## updated ibound

This is the new ibound array updated to reflect decisions made during the Sep 21-22 ESHMC meeting. I ran this in MKMOD5 and got usable output that then ran in mudflow using the same ibound. The mudflow output maps OK, and the ibound joins to the model grid and also looks OK. That is the extent of my error checking.

In\_Old\_Not\_New\_20101011.jpg  
364K

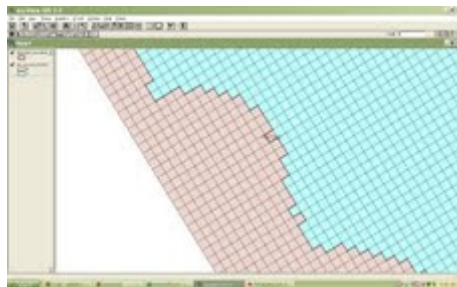
I only found one difference: Row 38 Column 13 is in the old i-bound but not in the new, per the attached GIS illustration.

Unless you holler quick I will assume this is correct and I'll apply it to the ESPAM2 data.

This looks correct Bryce. The removed cell looks like it is near Malad.
